Response to Submission: MP 07_0027 MOD 1
Modification to Shell Cove Boat Harbour Concept Plan

Modification to Shell Cove Boat Harbour Concept Plan

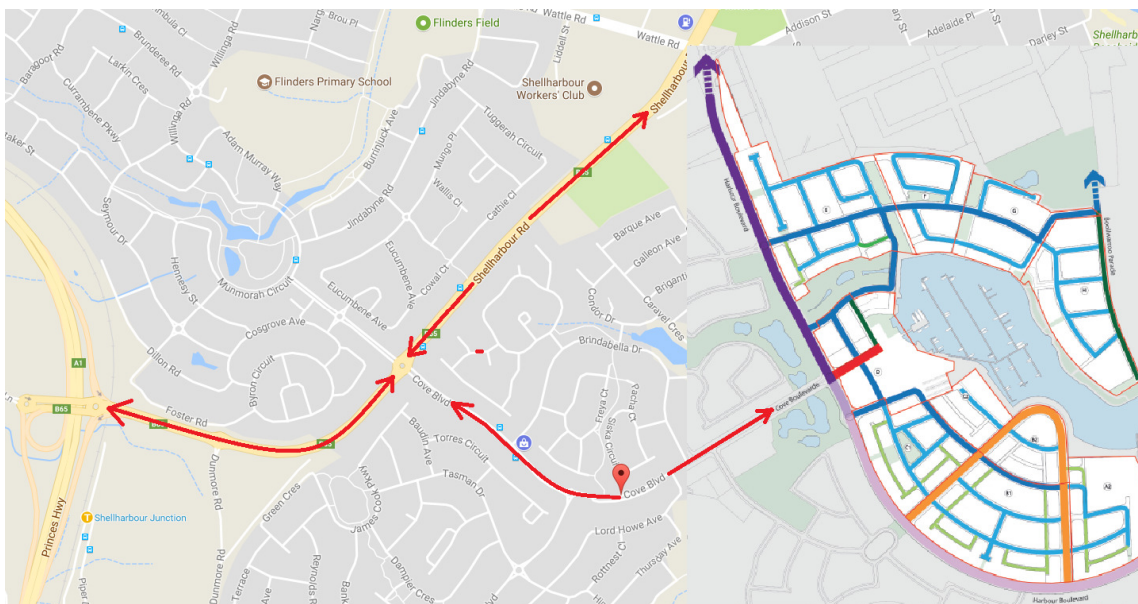
The calculated parking requirement of 265 spaces in Table 1 (item 5) would provide sufficient parking provision for the hotel. However, I disagree with assertion to reduce the required spaces from 265 to 209 – see Table 2, items 6 through 9. The arguments put forward supporting this reduction are very weak.

The statement that there is “no allowance for people to travel by shuttle bus/taxi” and hence parking rates should be reduced is unfounded. The only public transport option for holiday makers would be the train at Shellharbour Junction. There would be a very minute number of travellers from Sydney taking this option, with the majority wanting a car for the convenience and ability to experience the wider Shellharbour and South Coast area.

The case is presented that parking should not be required to accommodate 100% of the serviced apartments, stating an occupancy rate of 80% during peak times. I disagree with this assumption. There are minimal options for tourist accommodation in Shell Cove and the surrounding Shellharbour area. As Shell Cove grows in popularity as a destination, so will the occupancy of this hotel. It is not an unrealistic expectation that the hotel will near 100% capacity during peak times, with the timeframe of the peak to extend well over 1 month during the Christmas school holidays and following January summer holiday period. To make no provision for the entire parking requirements over this time would have a significant impact on the amenity of the hotel, the Marina Town Centre and surrounding residential area.

The suggestion in Item 12 that overflow parking for the hotel could be accommodated within the business park site located to the south east of the town centre is laughable. This nominated area is over 1.5km from the town centre, being separated by a residential housing estate.
